System Characterization Work Plan Part 1 (QAPP)
System Characterization Work Plan Part 2 (QAPP)
and
NJDEP approval letters dated October 20, 2016

Re: Receipt of Amended Sewer System Characterization Work Plan Part 1
PVSC, NJPDES Permit No. NJ0021016
Paterson City, NJPDES Permit No. NJ0108880
Newark City, NJPDES Permit No. NJ0108758
Kearny Town, NJPDES Permit No. NJ0111244
Harrison Town, NJPDES Permit No. NJ0108871
East Newark Borough, NJPDES Permit No. NJ0117846

**SYSTEM CHARACTERIZATION AND
LANDSIDE MODELING PROGRAM
QUALITY ASSURANCE PROJECT PLAN (QAPP)
PART 1**

Re: Technical Comments on the Sewer System Characterization Work Plan Part 1
Borough of East Newark, NJPDES Permit No. NJ0117846
Town of Harrison, NJPDES Permit No. NJ0108871
Town of Kearny, NJPDES Permit No. NJ0111244
City of Newark, NJPDES Permit No. NJ0108758
City of Paterson, NJPDES Permit No. NJ0108880
PVSC, NJPDES Permit No. NJ0021016

Figure 3 – Rainfall Volume Probability Plot

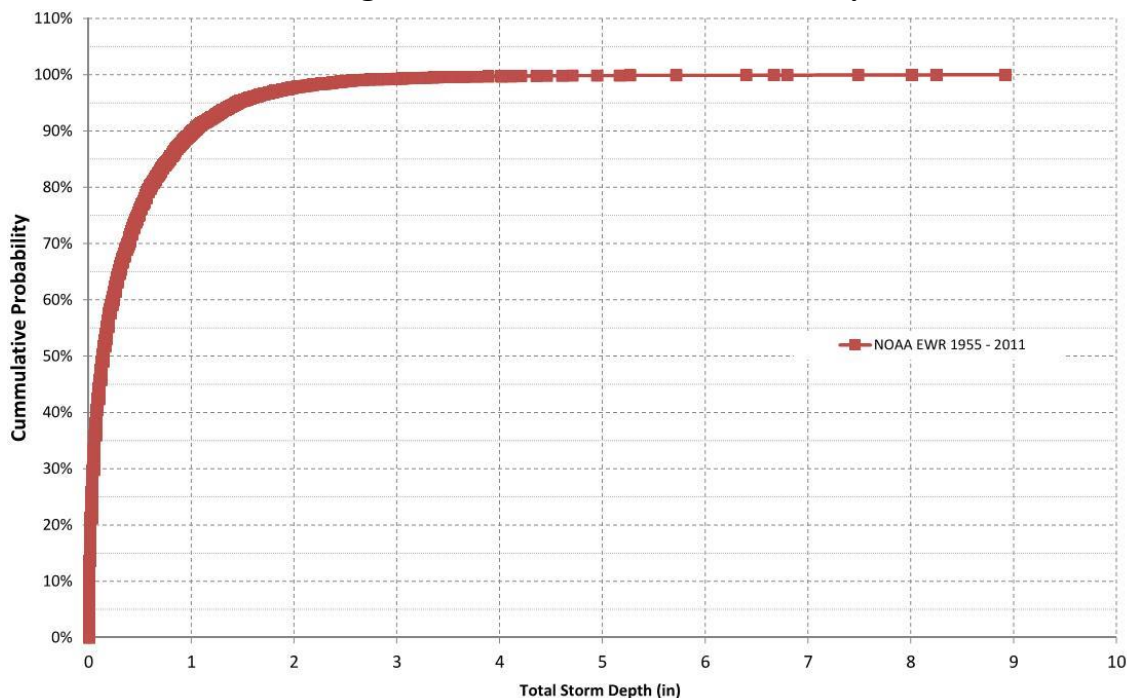
Comment 10: Under the list of figures on page 13, Figure 2 should be listed as “Rainfall Volume Probability Plot” as is indicated on Figure 2.

Figure 1 – PVSC Sewer District

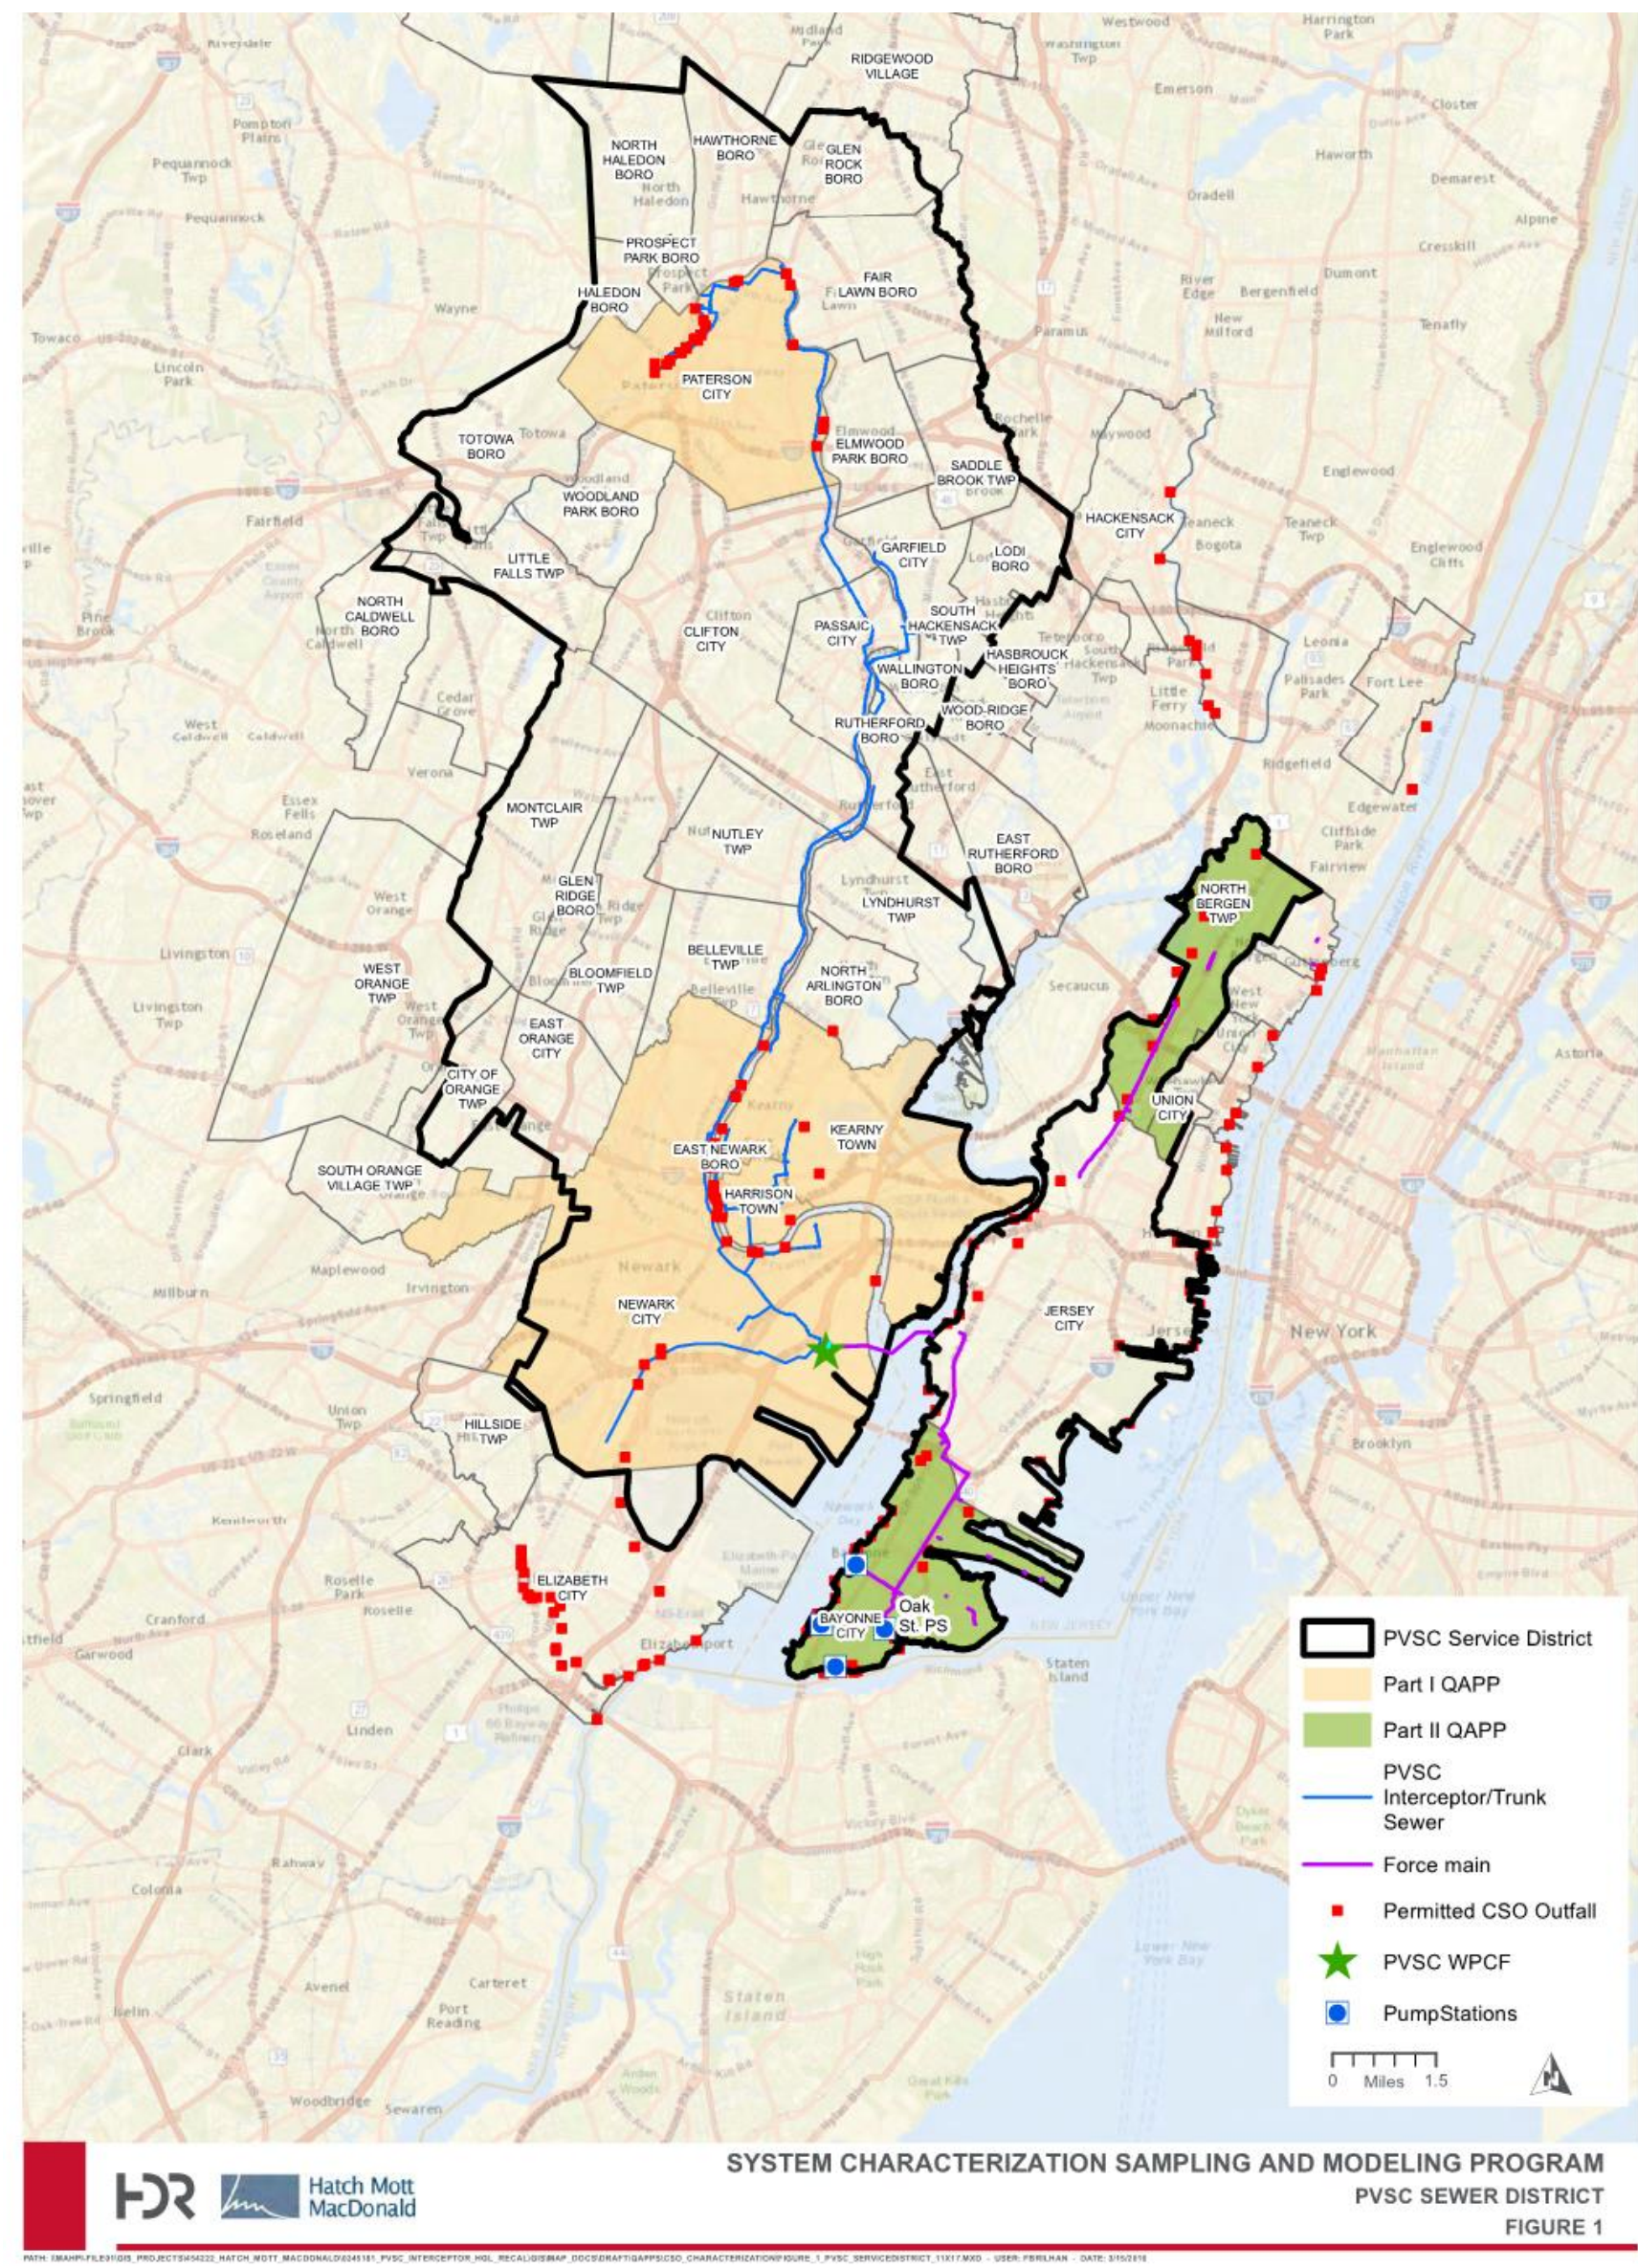
Comment 18: Figure 1 is included on page 14. While force mains are included in the legend, it appears that neither the force mains jointly owned by Bayonne MUA and Jersey City MUA nor the Hudson County force main is shown. Please revise the figure accordingly.
